**LOT RESITE  
 LOT 17  
 CATTAIL TRACE**

Re: Setback Variance Request for deck @ 3192 Lorenzo Lane

I have received your request for a variance regarding the ten (10) foot required setback from your septic tank to a deck/patio to be waived. This agency will grant you approval for this variance as long as no part of the deck extends over the septic tank and the footers are at least five (5) feet from the septic tank.

Side View  
Elevation

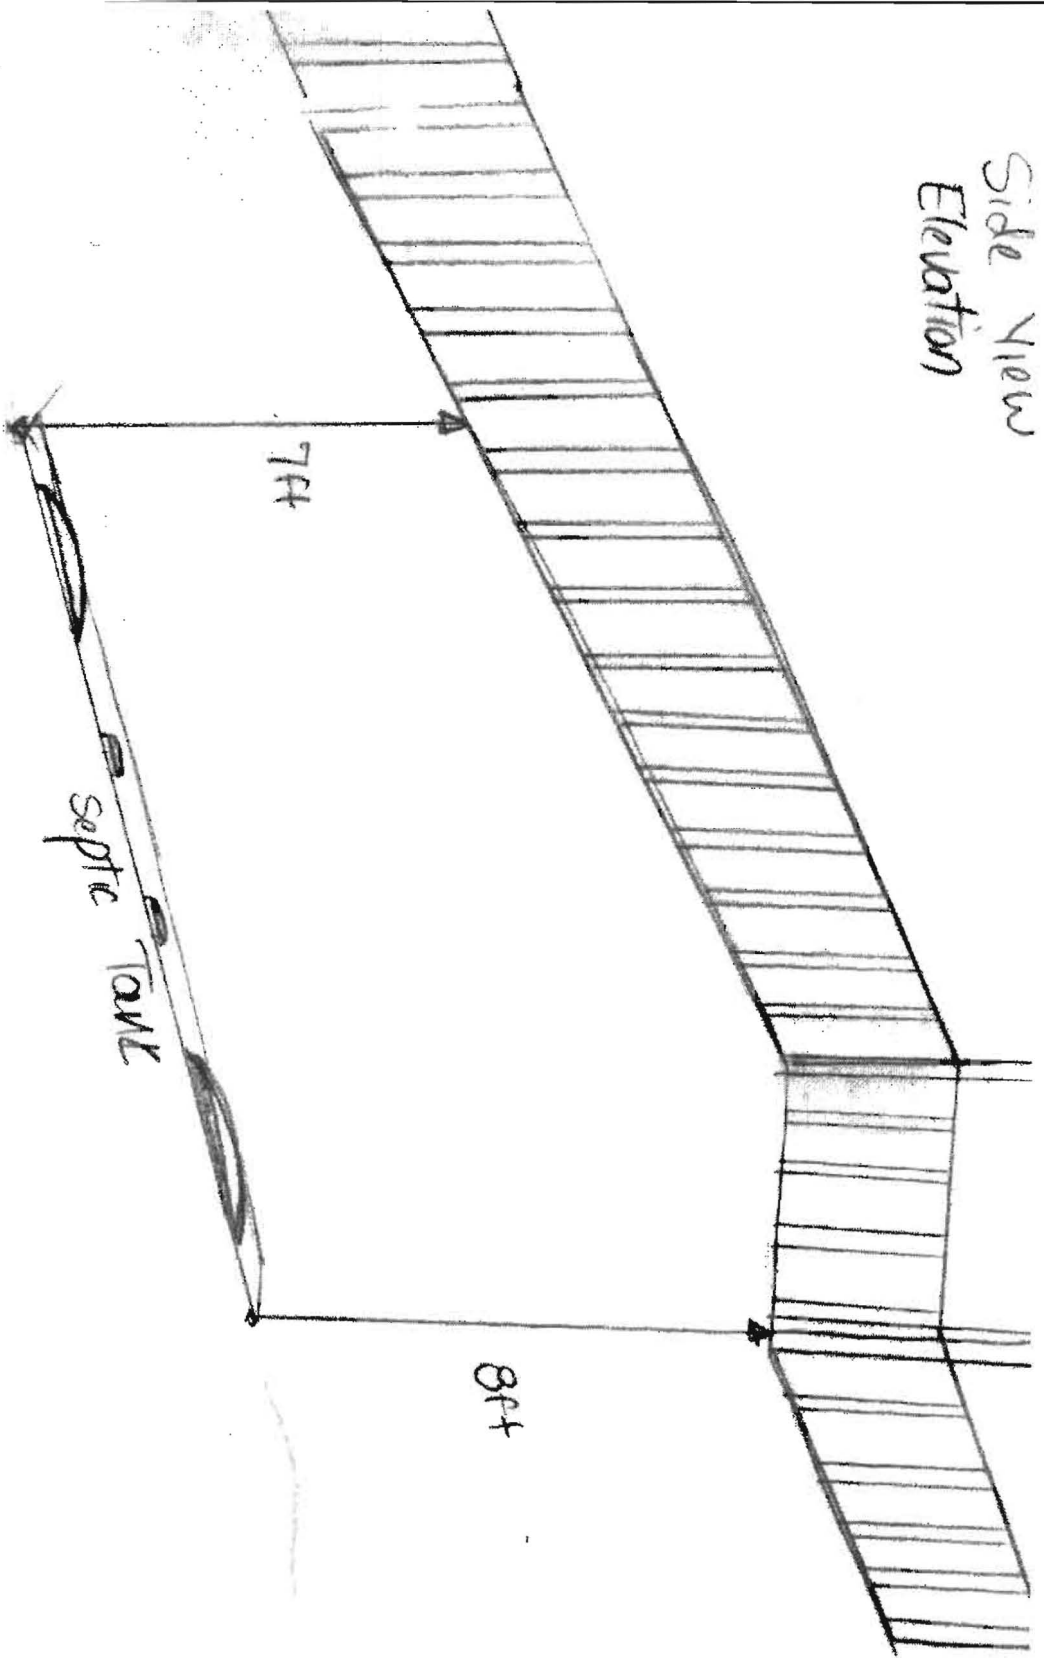
I am planning to have a contractor build a deck for us. As depicted in accompanying diagrams, the poles for the deck are to be situated no closer than 6 ft from the exterior wall of the septic tank (the wall being 18 inches away from the manhole covers). In the diagrams, I am only showing the poles closest to the septic tank. A small portion of the deck will overhang over a 10sq inch area of the septic tank but the elevation will be at least 6.5 ft.
